ELIOT QUARRY (SMP-23) RECLAMATION PLAN AMENDMENT

FINAL SUBSEQUENT ENVIRONMENTAL IMPACT REPORT *CHAPTERS 1—7 AND APPENDICES*

State Clearinghouse No. 2019060144

JUNE | 2021

Figure 1
Eliot Quarry
Groundwater Map

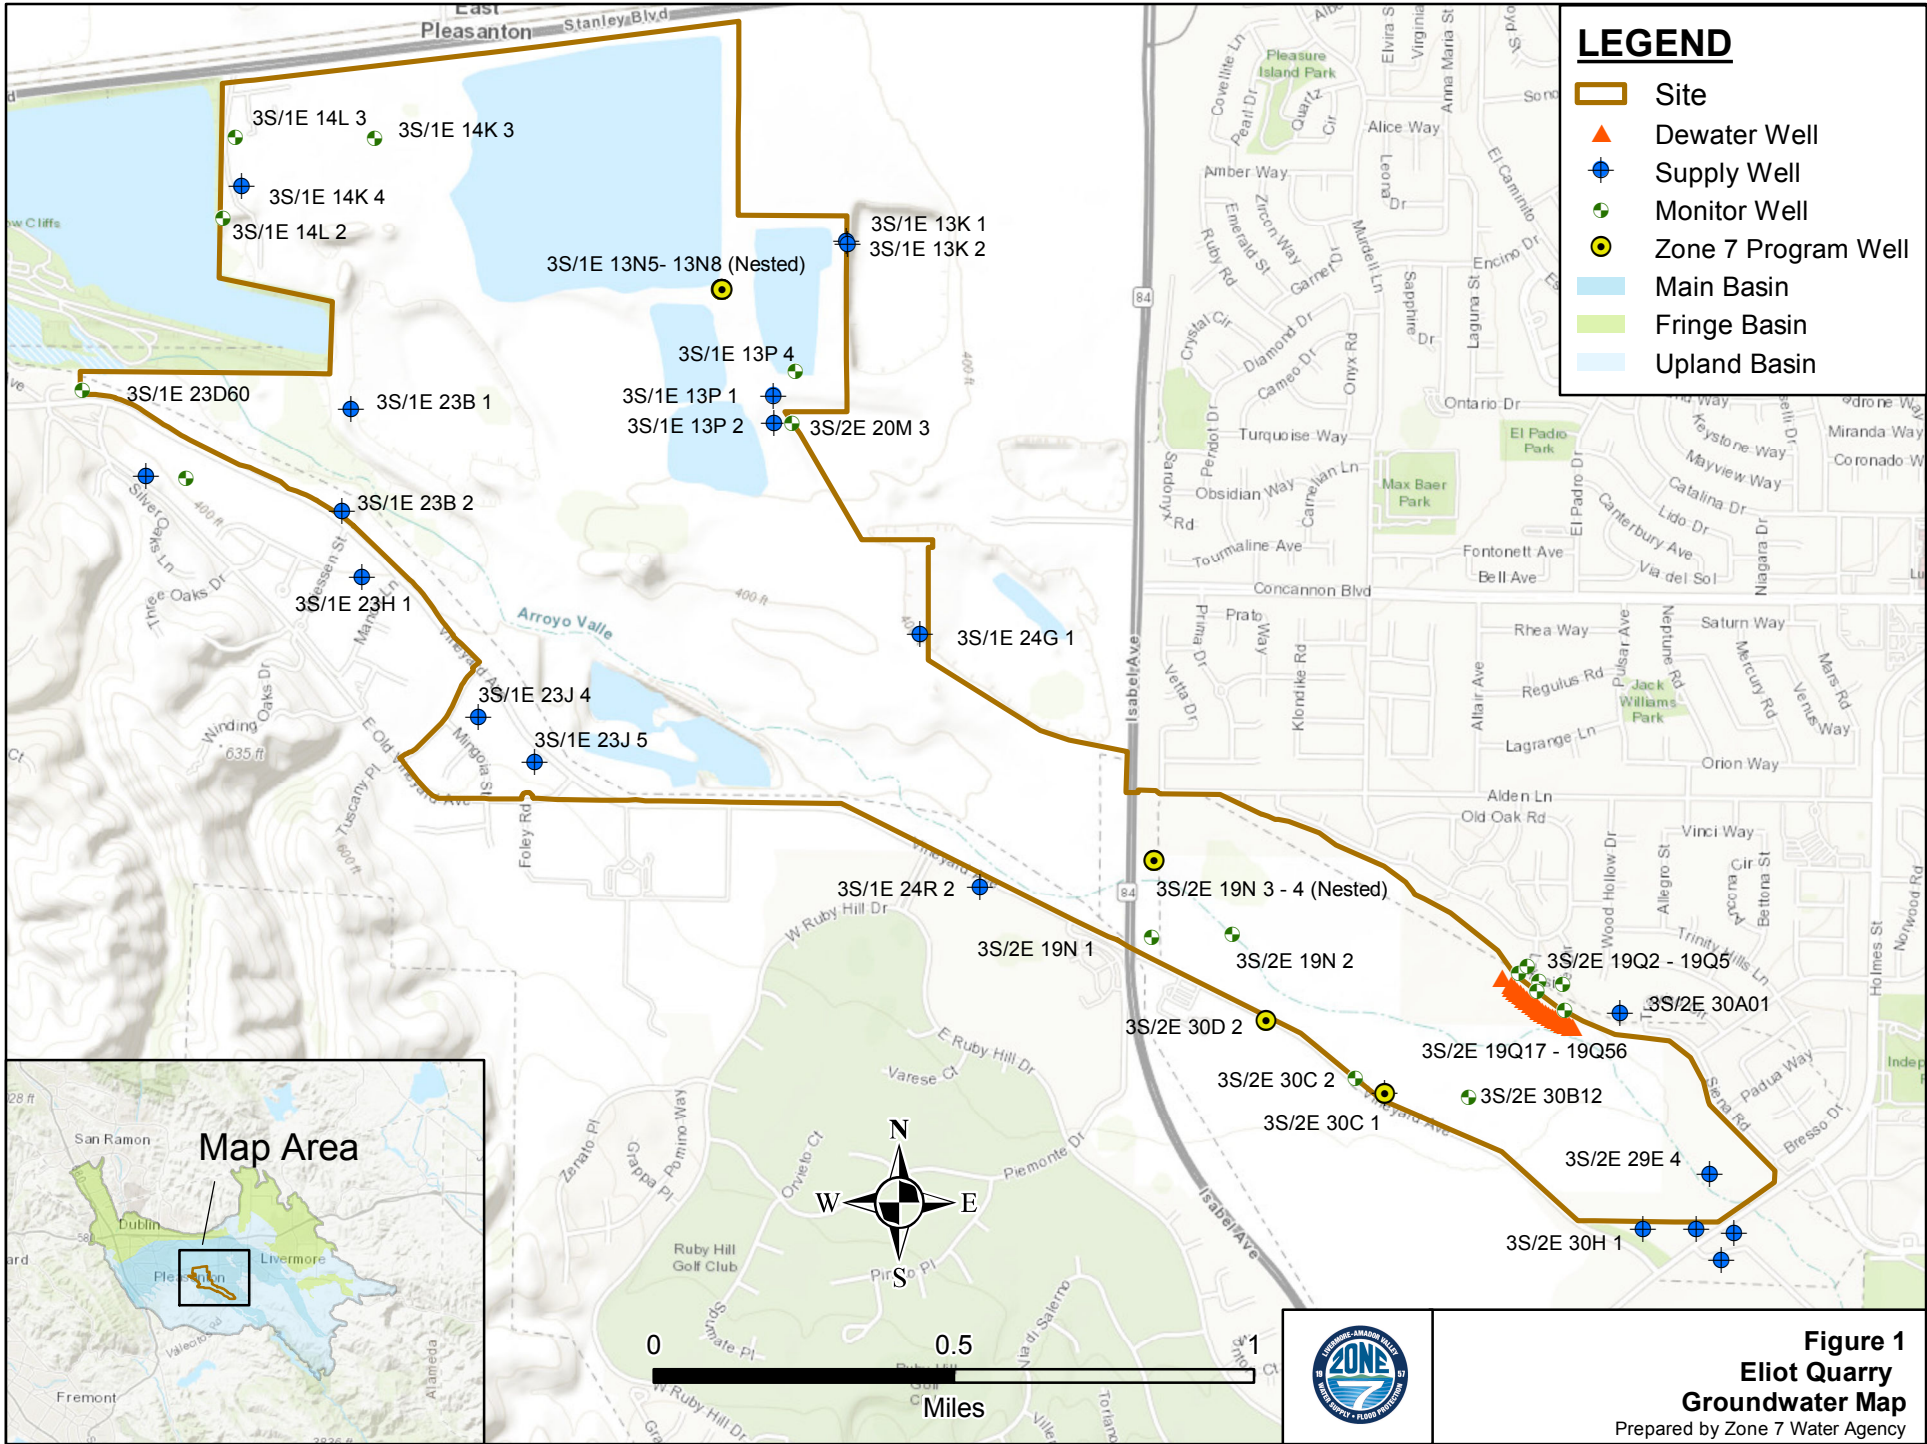
The water quality assessment was performed based on "average" concentrations of constituents of concern, without giving any consideration to maximum detected concentrations in the area. For example, utilizing average concentrations for Hexavalent Chromium (Cr6) indicates no need for any mitigation measures. But examples from where active mining has taken place, the maximum concentrations for location R24 is 17 ug/l and P42 is 9.6 ug/l. These indicate that some mitigation/monitoring is necessary in active pits – likely due to the release of metals such as chromium, iron, and manganese from the scraping of the surface of soils and rocks during mining.

Therefore, we have the following recommendations for additional mitigation measures:

- i). Recommended mitigation: Flexibility should be built into the mitigation measures to address changes in MCLs and/or to address contaminants of emerging concern, such as Per- and Polyfluoroalkyl Substances (PFAS) and Hexavalent Chromium (Cr6).

- ii). Recommended mitigation: CEMEX to prepare an updated water quality assessment every five years to incorporate Zone 7 Groundwater Sustainability Plan updates and/or new or revised drinking water MCLs and mitigate any associated impacts.
